**Re: Zoning Application No. 223-34, 900 Long Ridge Road, Stamford, CT**

On behalf of 900 Long Ridge Road Property Owner LLC, we writing to address your comments in the Interoffice Memorandum dated August 23, 2023. In general, we have no issues with your suggested changes and offer the following, more detailed, point by point responses in support:

**STORM PIPES: VIDEO INSPECTION**  
**900 LONG RIDGE ROAD**  
**STAMFORD, CT**

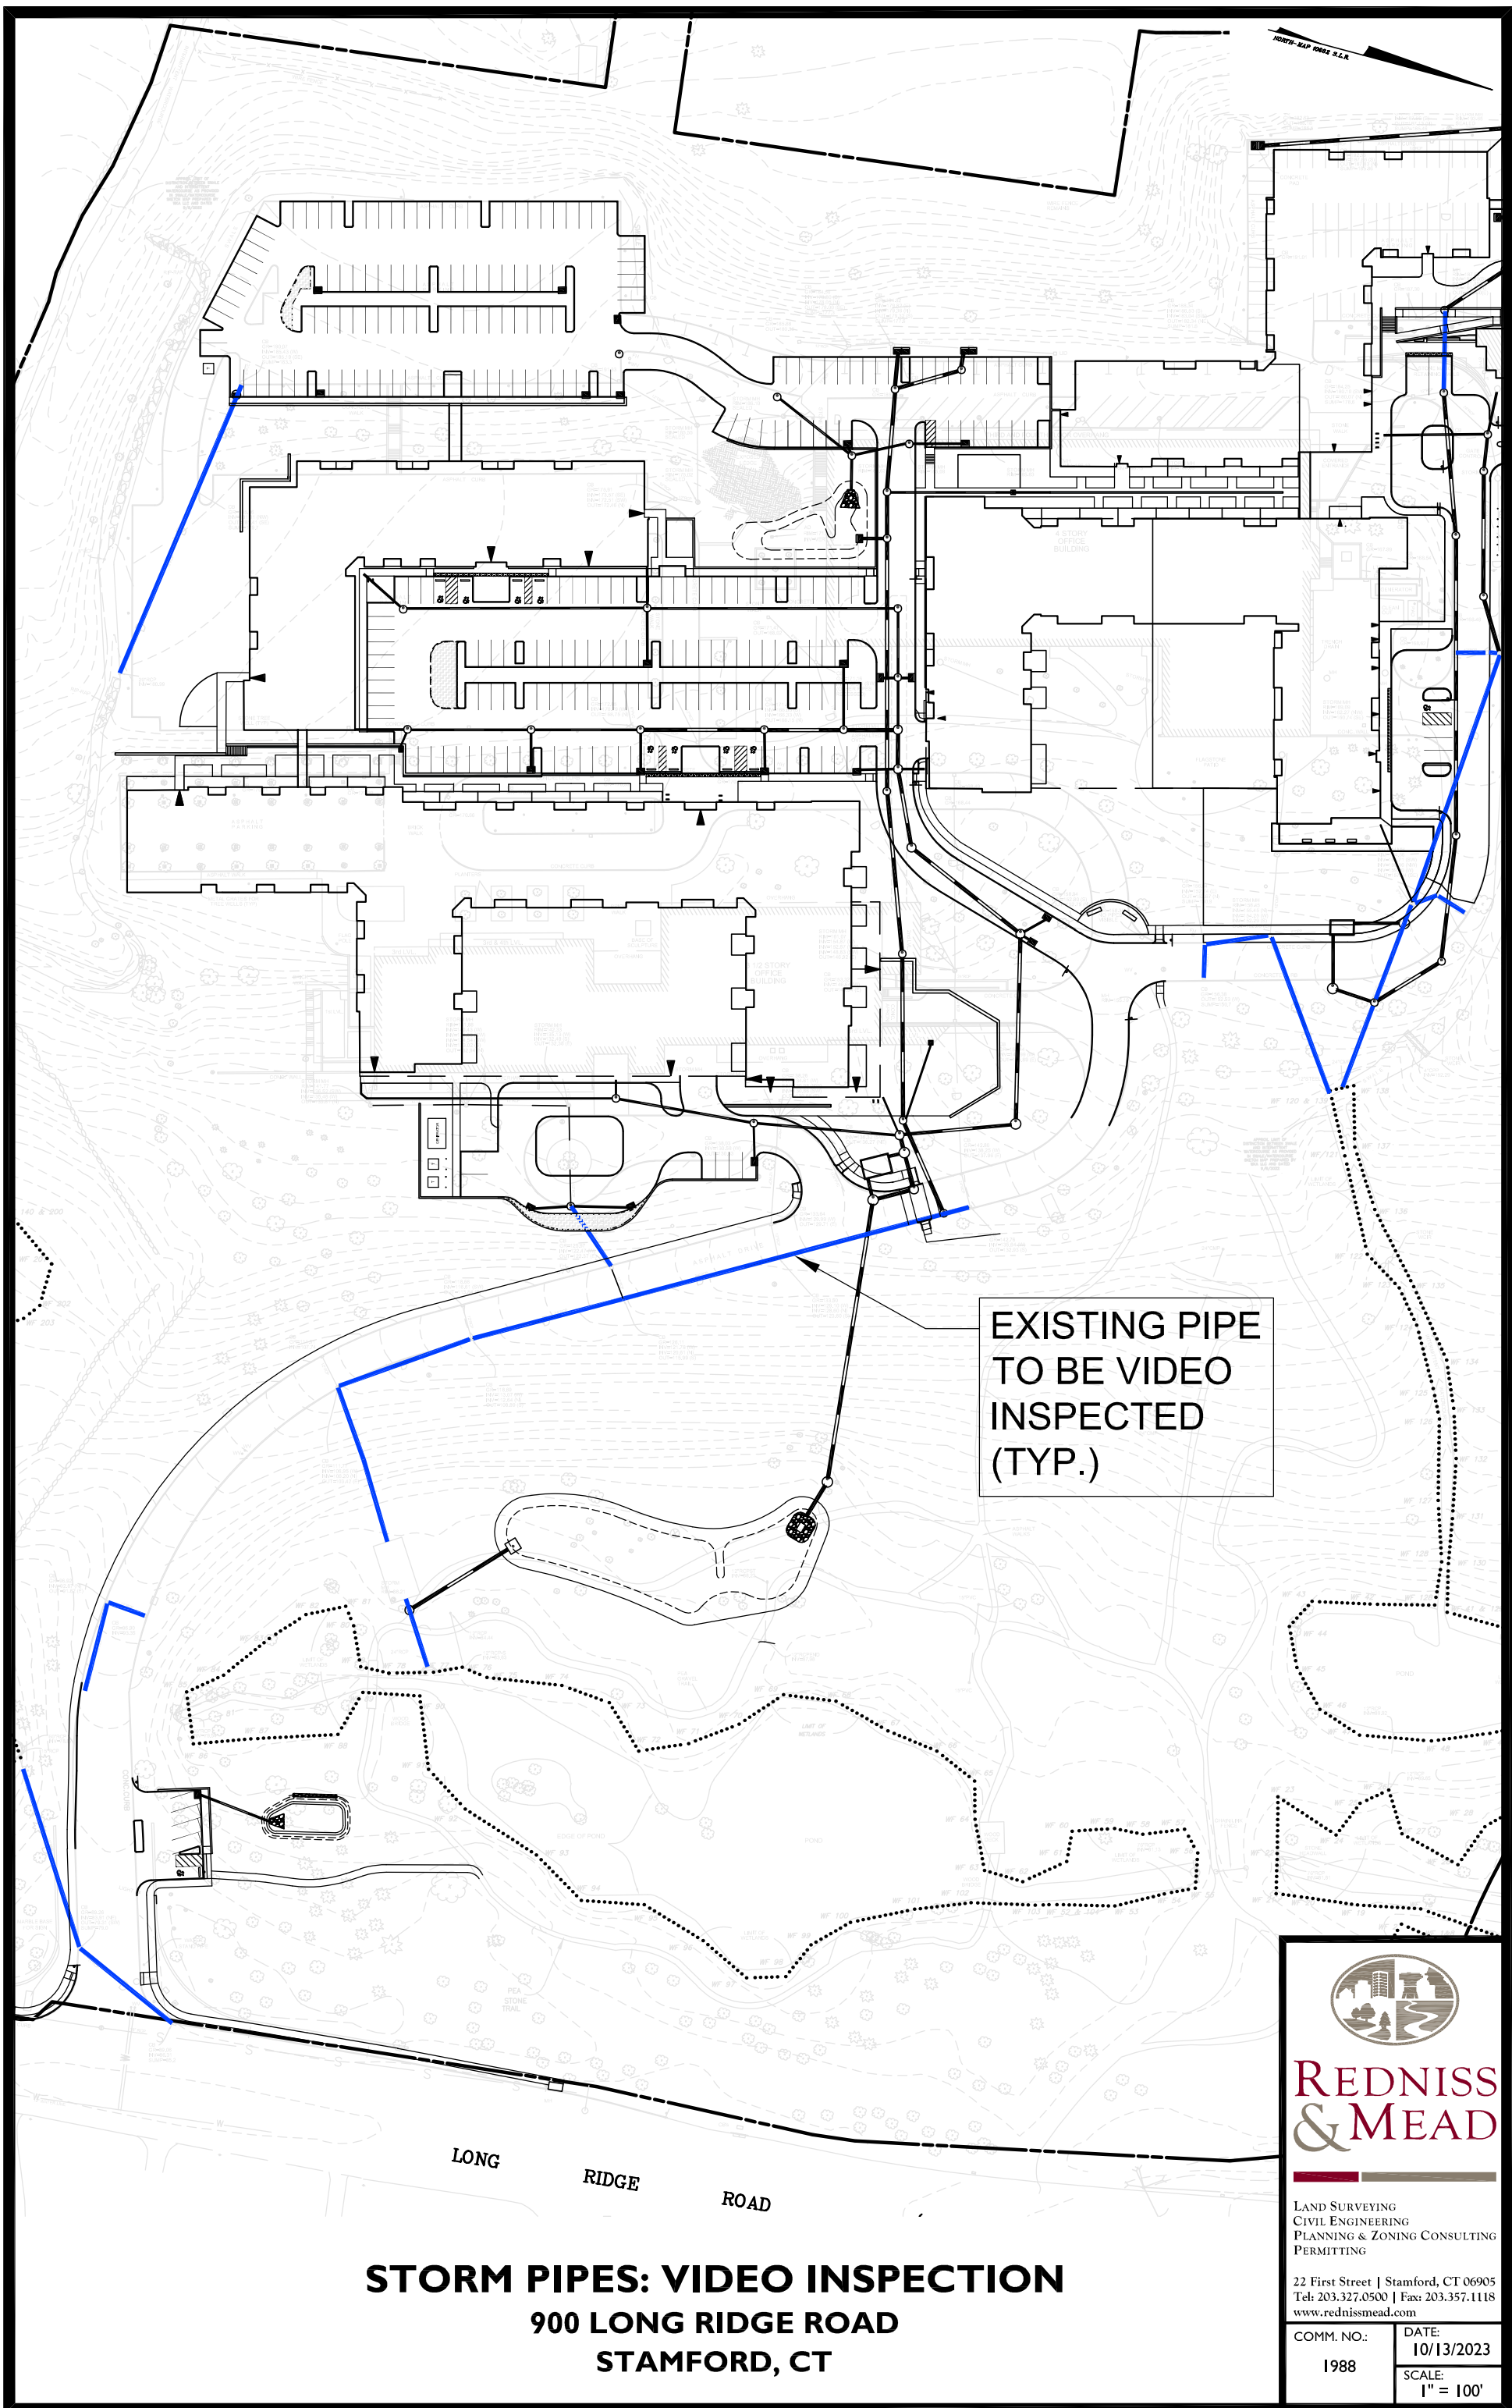
7. As previously discussed, we are in agreement as to which existing storm structures shall be video inspected. The attached exhibit shows these structures. The existing 8" sanitary line has been previously video inspected by OneVac Sewer and Drain Services. The results will be reviewed with WPCA staff prior to issuance of a Building Permit to confirm the limits of replacement proposed as part of this development.

EXISTING PIPE  
TO BE VIDEO  
INSPECTED  
(TYP.)
